Official Transcript of Proceedings
NUCLEAR REGULATORY COMMISSION

Title: Advisory Committee on Reactor Safeguards
Nuscale Design-Centered Subcommittee

NUSCALE DESIGN-CENTERED SUBCOMMITTEE

(Excluding Sections 3.7, 3.8, and 3.9.2)

Detail from FSAR Figure 3.9-1

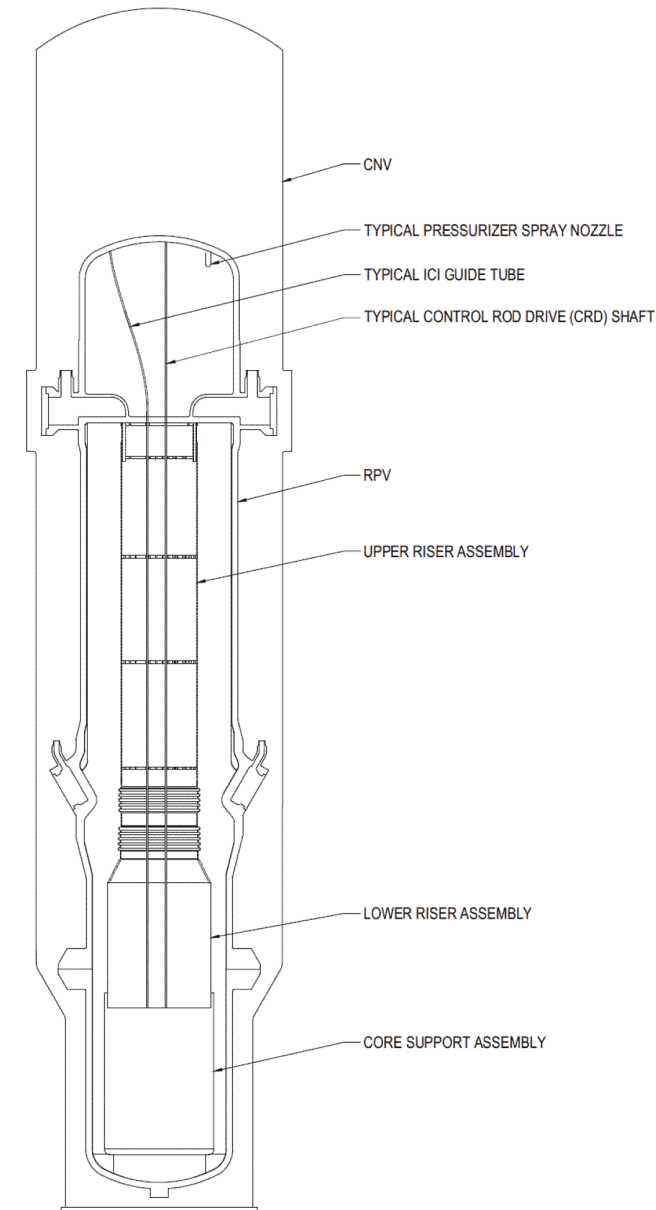
- Differences from DCA
 - Additional transients: density wave oscillations, loss of feedwater, initial test program, secondary leakage tests, control rod drive system piping failure
 - Removed transients: hydrogen detonation and hydrogen detonation with deflagration-to-detonation transition
 - Transients with cycle changes: containment flooding and drain, power ascent from hot shutdown, and turbine trip without bypass
- Audit Results
 - Three audit questions resolved
- RAI Results
 - No RAI questions

Detail from FSAR Figure 3.9-3

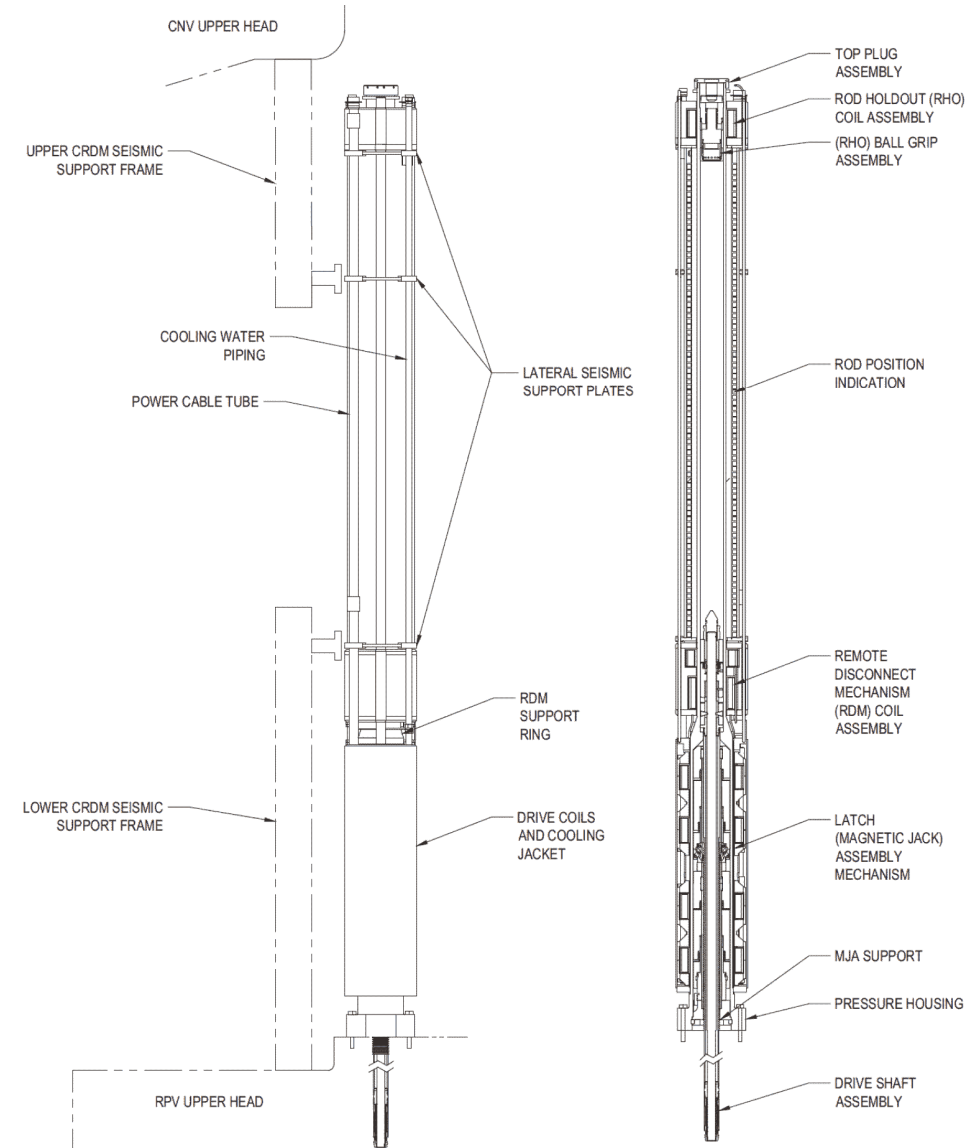
- Differences from DCA
 - Change from welded connection to bolted connection
- Audit Results
 - Seven audit questions resolved
- RAI Results
 - RAI 10131 (Question 3.9.4-8)
 - Provided additional information for steam generator set screws
 - Added additional augmented visual examinations
 - RAI 10131 (Question 3.9.4-9)
 - Provided additional information for the control rod drive mechanism housings and associated connections
 - Resulted in no changes to the SDAA

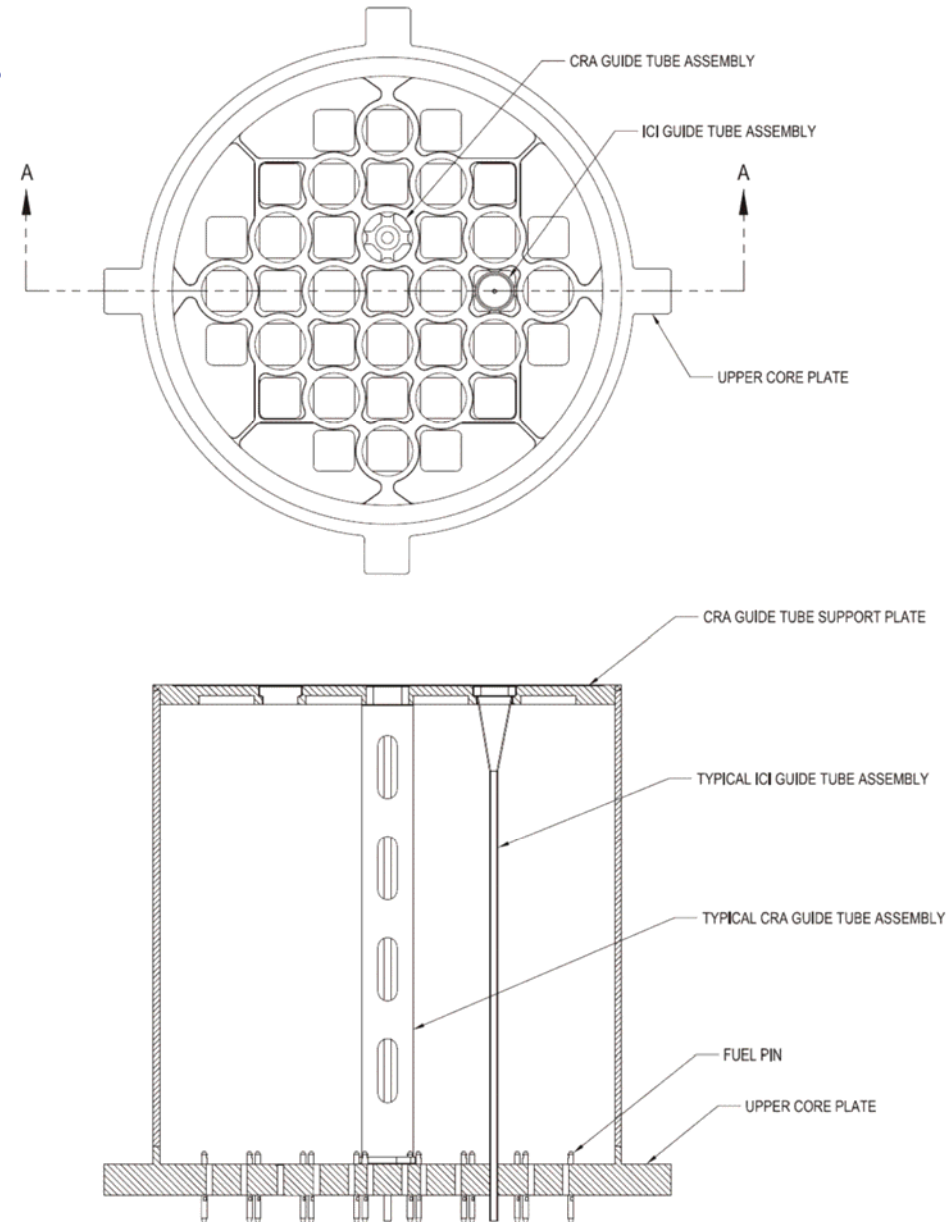
- Differences from DCA
 - Upper Steam Generator Support – Reclassified from internal structure to a Class 1 Support
- Audit Results
 - No audit questions
- RAI Results
 - No RAI questions
